PROJECT: BLM Site II - Update for Onsite Residential Development

SUBMITTAL: 4th Submittal

CITY OF LAS VEGAS		DATE:
INTER-OFFICE MEMORANDUM		September 21, 2016
TO: Land Development Services Department of Building & Safety		FROM: Albert Sung, P.E. Flood Control Project Engineer Department of Public Works
SUBJECT:	Drainage Study for:	
	BLM Site 11 – Update for Onsite Residential Development	
Cross Streets:	SWC of Tropical Pkwy & Michelli Crest Way	
File Number:	F:\Depot\DSMemos\DS4789D.doc	
Parcel Number:	126-25-701-001	
Zoning Action:	ZON-62343; VAR-63098; WVR-63099; TMP-63100 & VAR-63259	
FEMA Flood Zone	YES	NO X
Proposed Storm Drain	YES	NO X
		COPIES TO: Triton Engineering DR Horton Inc. Bart Anderson, P.E., DevCo CCPW

DR HORTON
BLM SITE 11
ON-SITE DRAINAGE PLANS
GRADING PLAN III

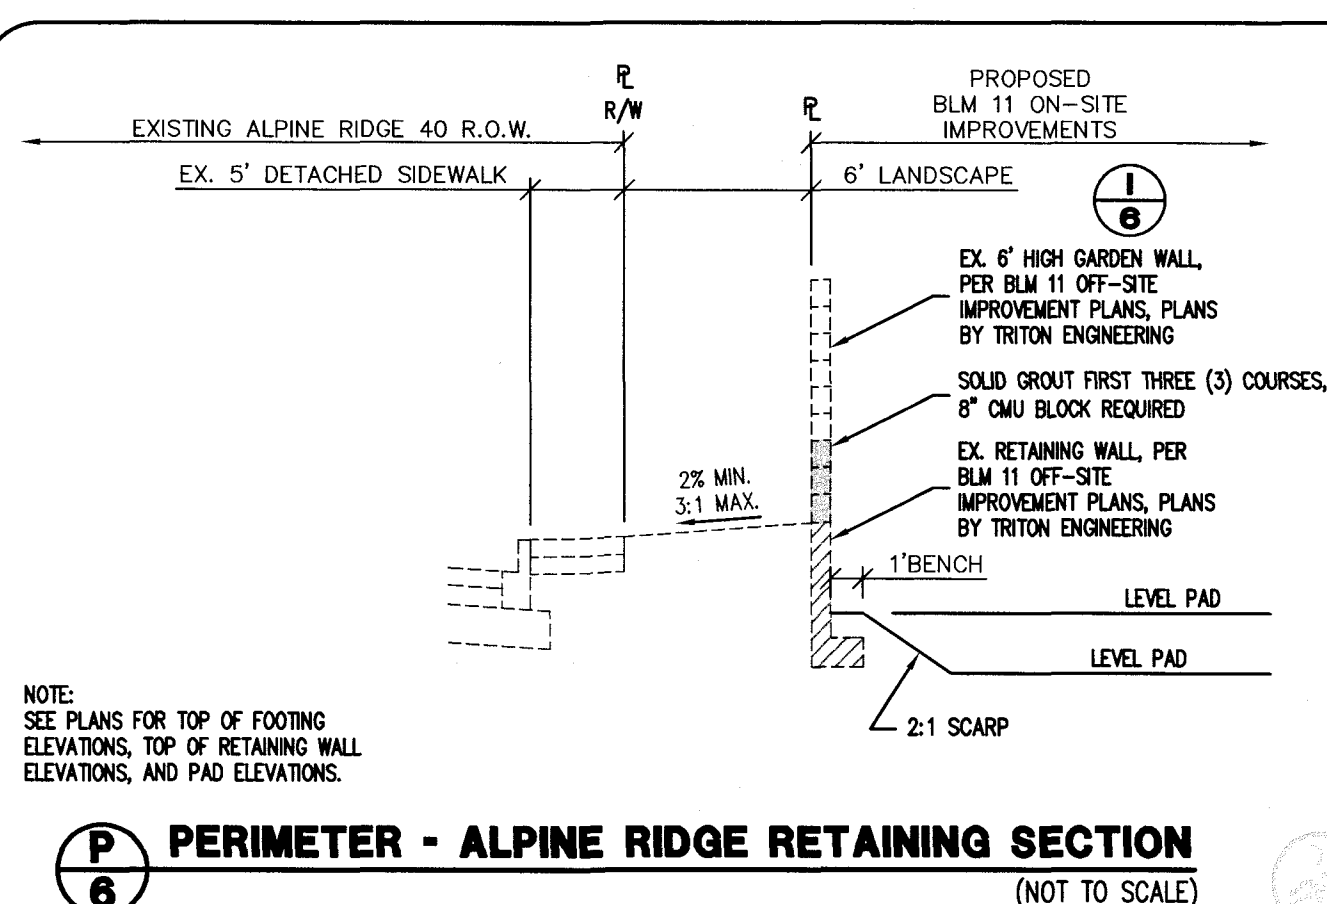
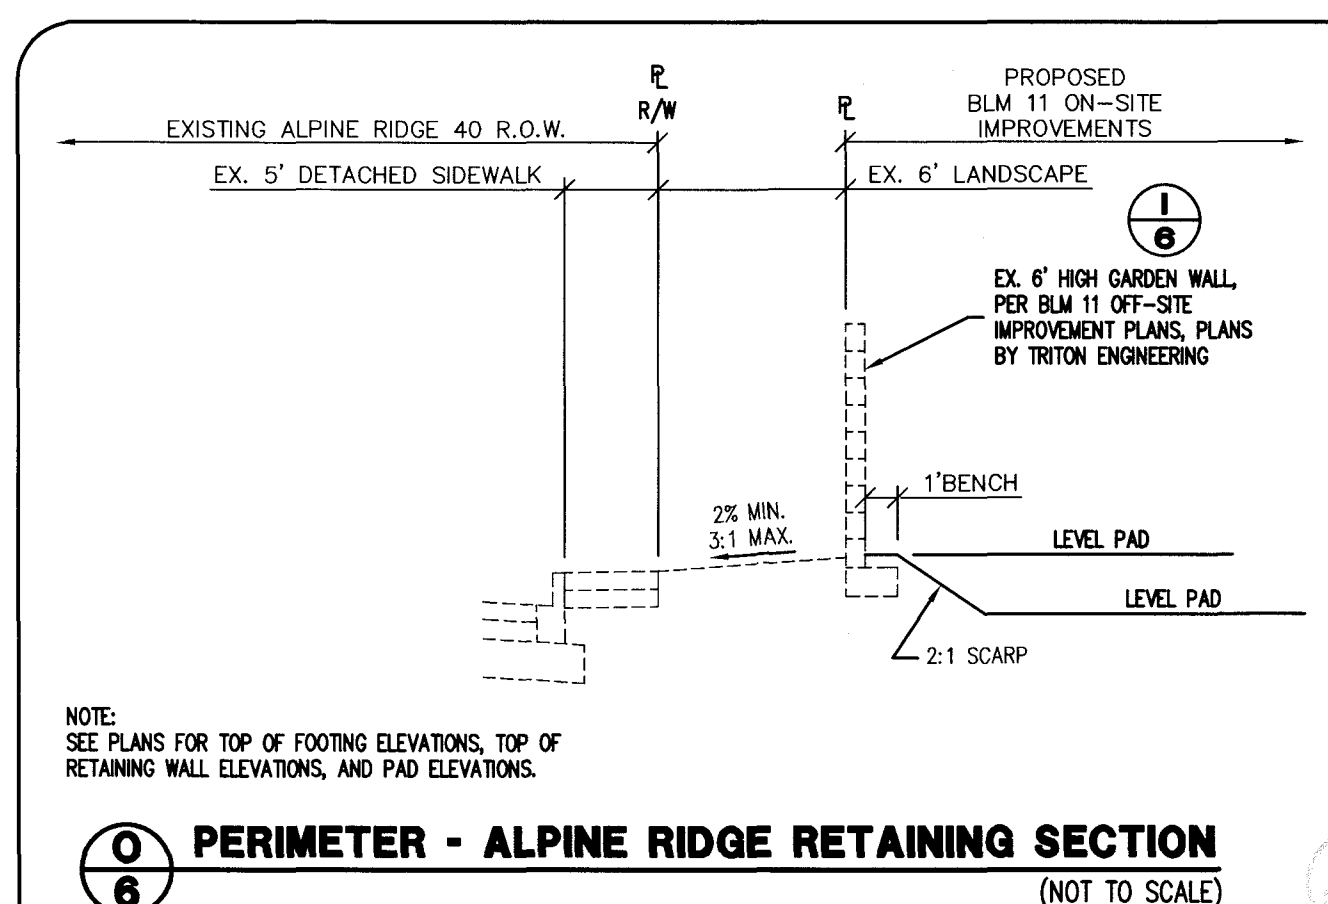
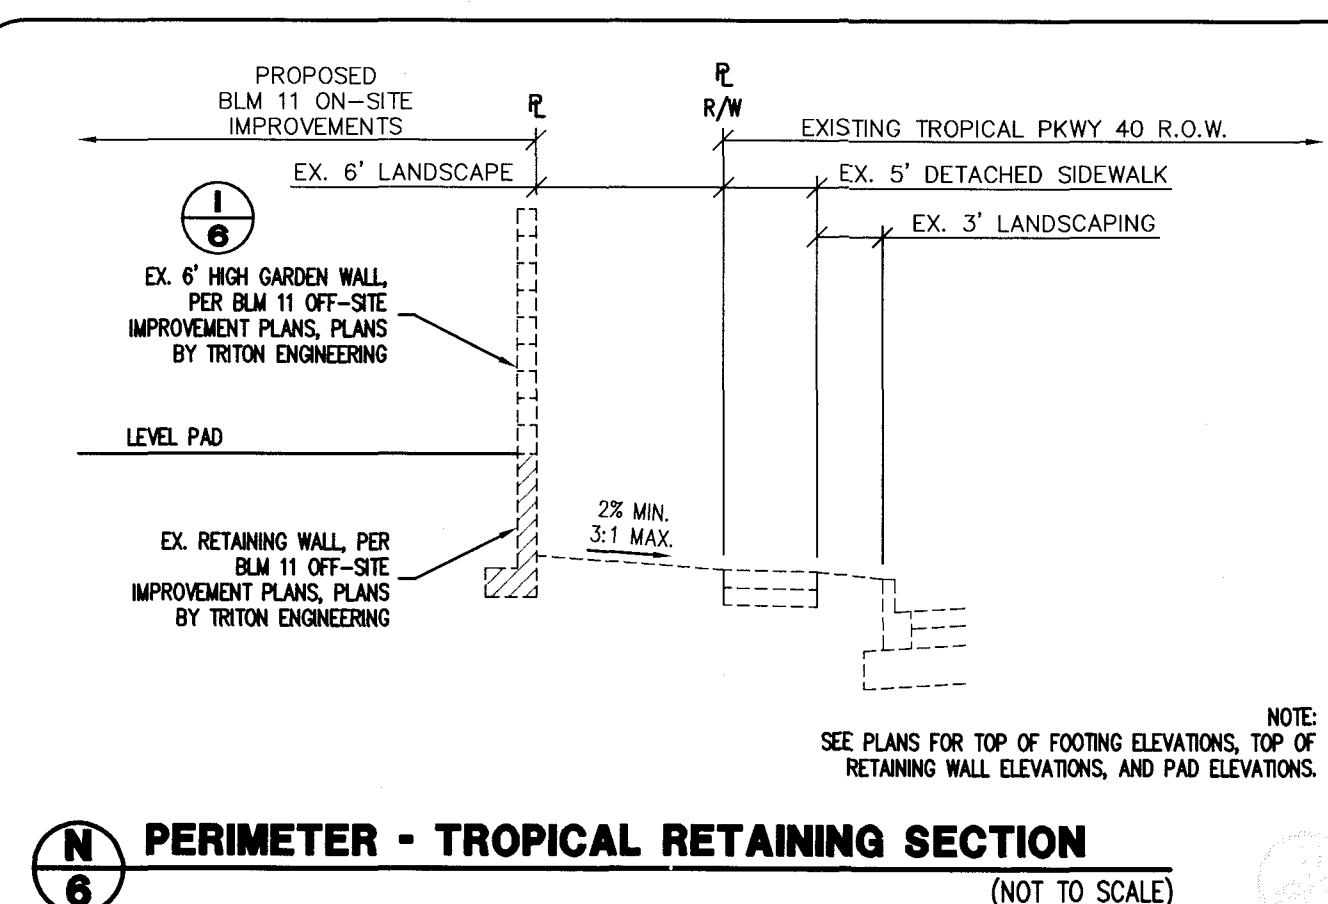
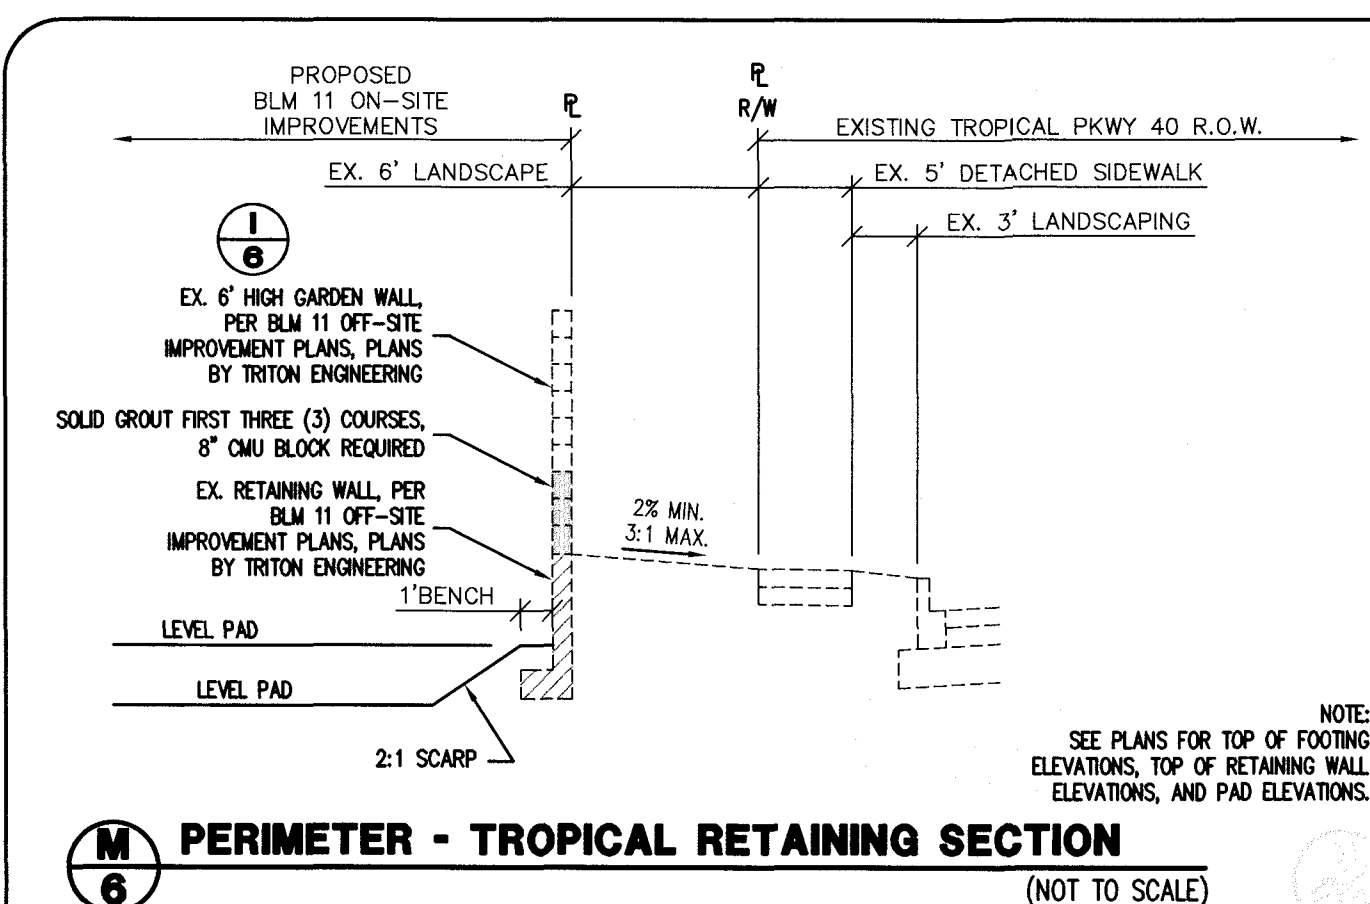
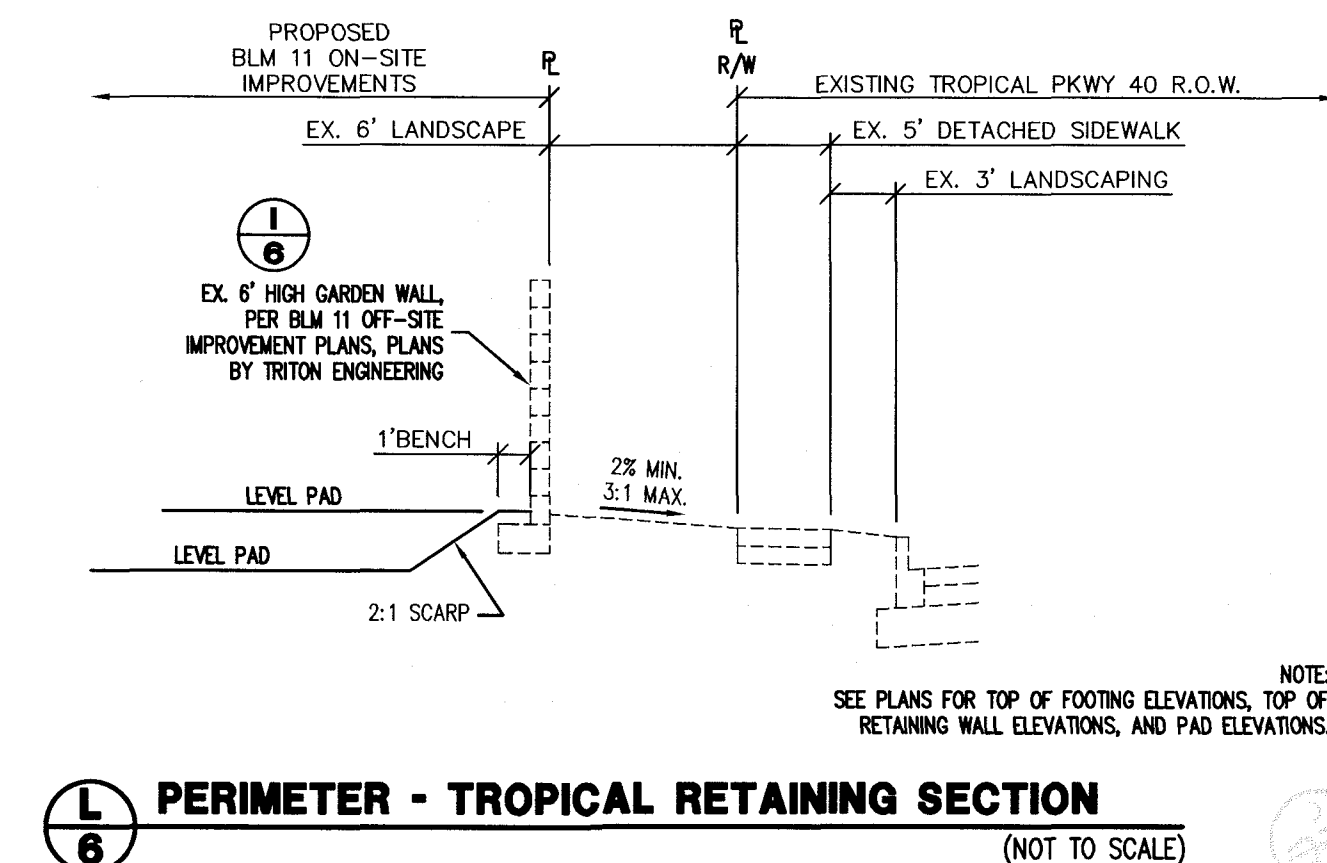
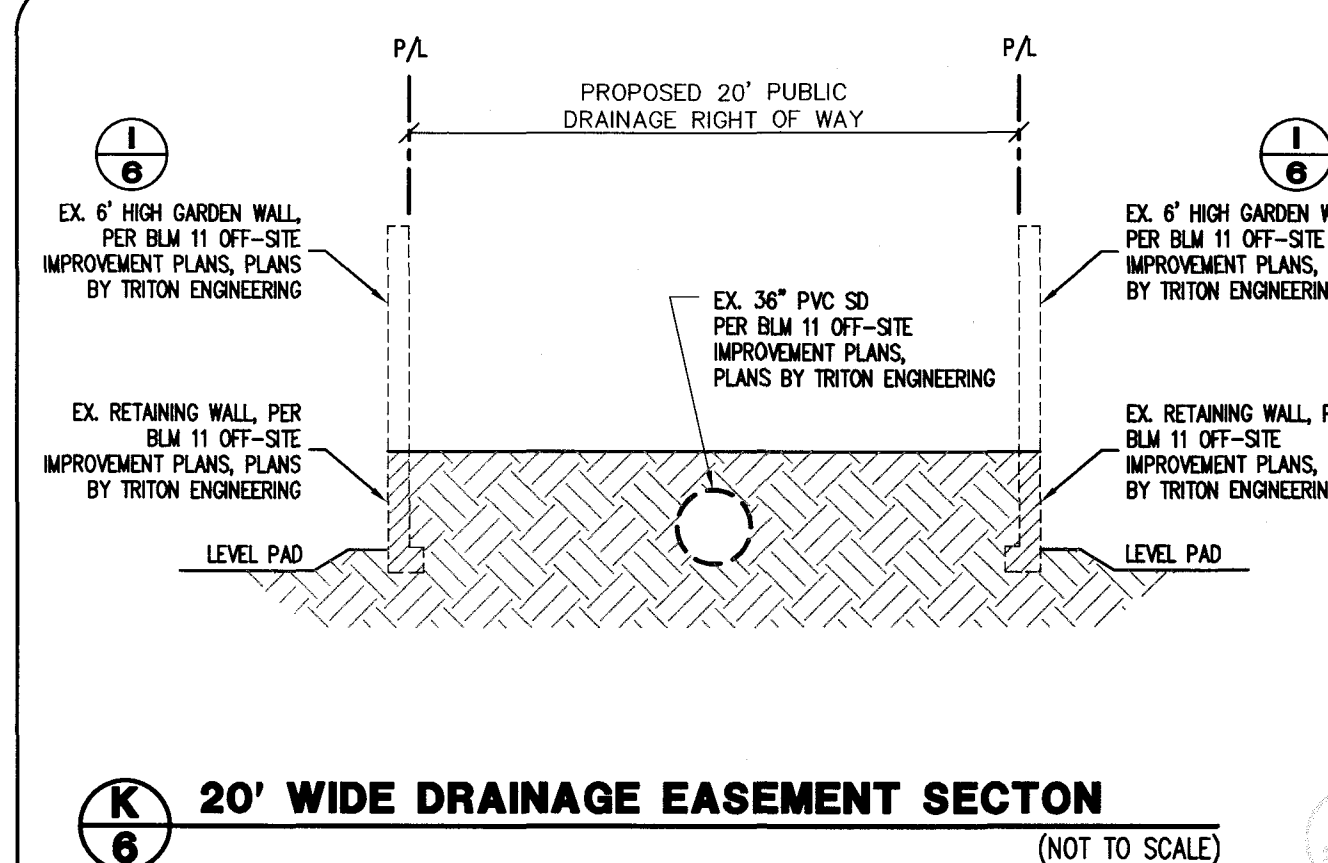
- Second Request: Sheet 5 (Grading Plan III):** An existing 24"-storm drain and a 12"-bleeder line appears to be within the *Clark County* jurisdiction. Consult with the *Clark County Public Works Department* what need to be done with the bleeder system.
